ALBEMARLE COUNTY PLANNING
STAFF REPORT SUMMARY

Project Name: SP201800011 The Regents School of Charlottesville – Reservoir Road	Staff: Tim Padalino, AICP, Senior Planner
Planning Commission Hearing: August 20, 2019	Board of Supervisors Hearing: September 18, 2019
Owner: University of Virginia Foundation (UVAF)	Applicant: The Regents School of Charlottesville
Acreage: 19.1 acres	Special Use Permit for: “Private School” (Z.O. 13.2.2.5)
Tax Map Parcels (TMP): 076000000001700 and 075000000006600	Magisterial District: Samuel Miller
Location: Reservoir Road, approximately 900 feet west of the intersection with Fontaine Ave. Ext. and across the street from Foxhaven Farm Road School Districts: Murray – Elementary, Henley – Middle, and Western Albemarle – High	Zoning/by-right use: R-1 Residential (1 unit/acre); Zoning Overlay Districts: Managed Steep Slopes; Preserved Steep Slopes; Airport Impact Overlay; Entrance Corridor Requested # of Dwelling Units/Lots: Zero (N/A)

SP201800011 The Regents School of Charlottesville – Reservoir Road

Figure 7: “Western Urban Neighborhoods Parks and Green Systems Plan” (S+W Master Plan p. 25)

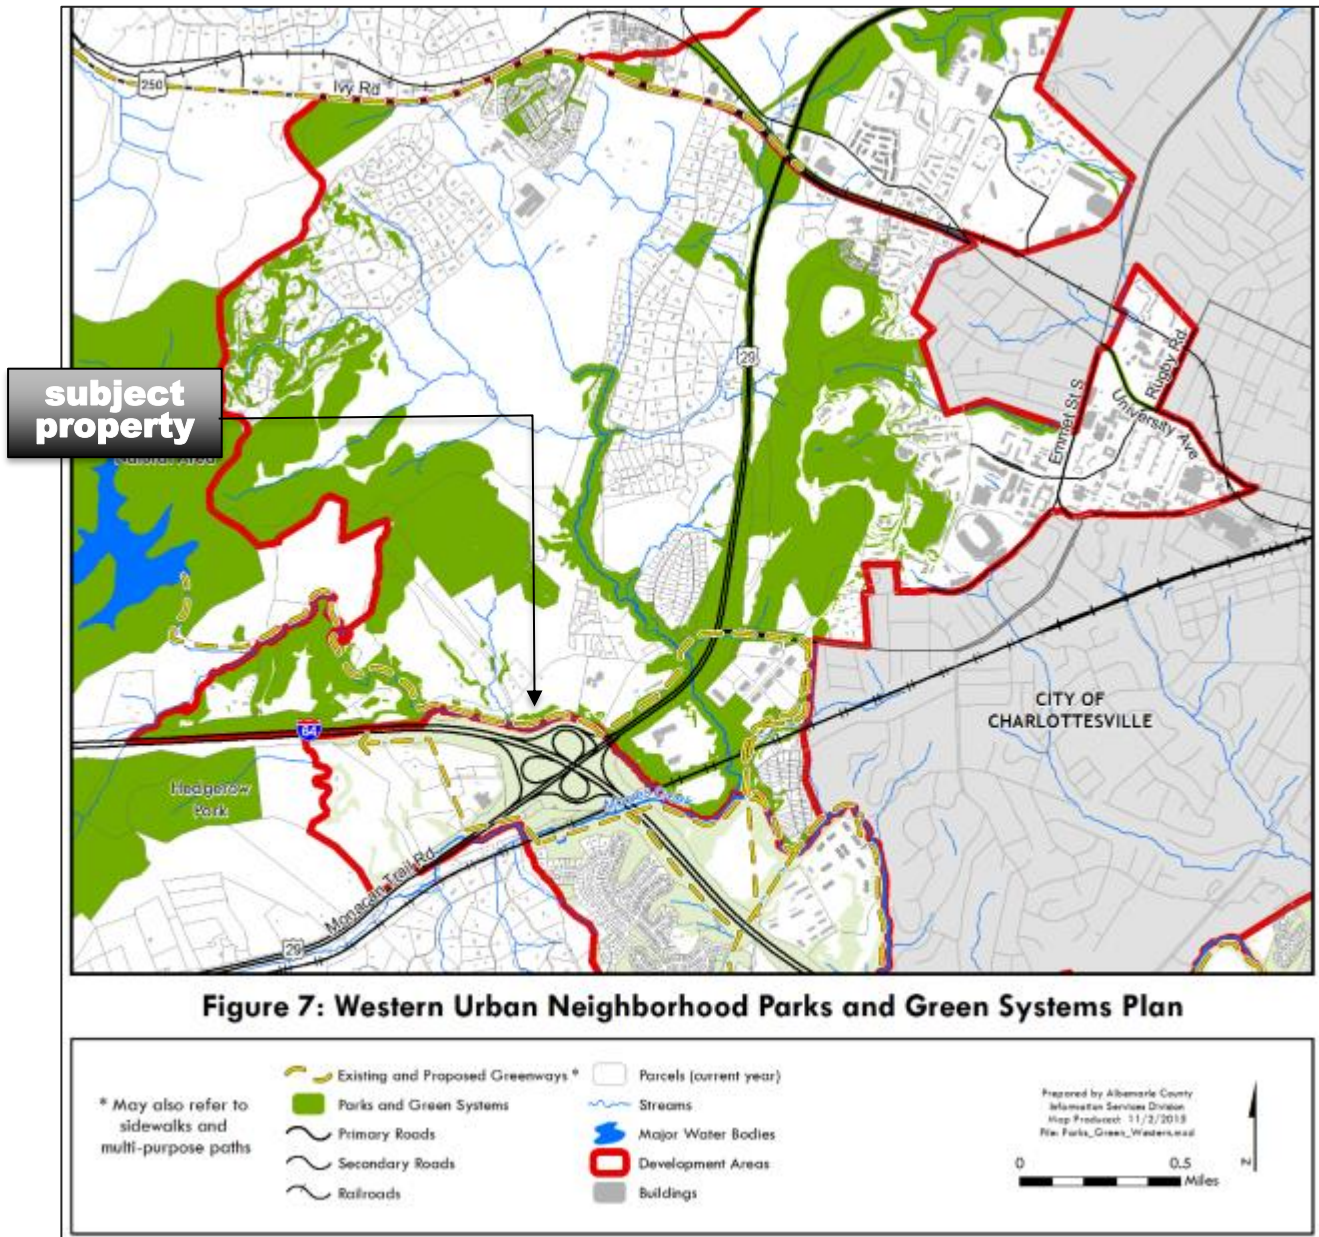
Additionally, staff have identified an element of the Parks and Green Systems Plan which is not addressed in this proposal. Specifically, that Plan shows a proposed greenway conceptually located along or near the tributary to Moore's Creek which runs along and near the southern boundary of the subject property. No such trail, multi-use path, or other greenway connection appears to be contemplated on the Concept Plan or referenced in other application materials.

Staff acknowledges that this issue had not previously been identified or discussed with the applicants; it was only identified during this most recent review (following the July 1st resubmittal). Staff also acknowledges that the subject property (TMP #75-66 and #76-17) does not have continuous frontage along this waterway, and further acknowledges that property owned by VDOT is situated between the subject property and the waterway in some locations.

Nevertheless, based on the recommendations in the S+W Master Plan (including the "Western Urban Neighborhood Parks and Green Systems Plan" and also the "Plan for Future Parks and Green Systems" and "Trail Recommendations" language identified above), and based on recent coordination between staff in the Community Development Department and the Parks and Recreation Department, staff believes this proposed greenway should be accounted for during the legislative zoning process that is required in order for the (proposed) development of the subject property to be permissible. Accordingly, staff recommends a condition of approval (#5) be established in order to address this issue.

5. The Concept Plan must be revised to make reasonable accommodation for the proposed greenway identified on the Parks and Green Systems Plan (S+W 25) and referenced in the Trails Recommendations (S+W 54), both of which are contained in the “Southern and Western Urban Neighborhoods Master Plan,” by providing a commitment to reserve lands along or near the southern boundary of the subject property (TMP #75-66 and 76-17) and along or near the tributary of Moore’s Creek for future dedication to the County for use as a greenway trail.
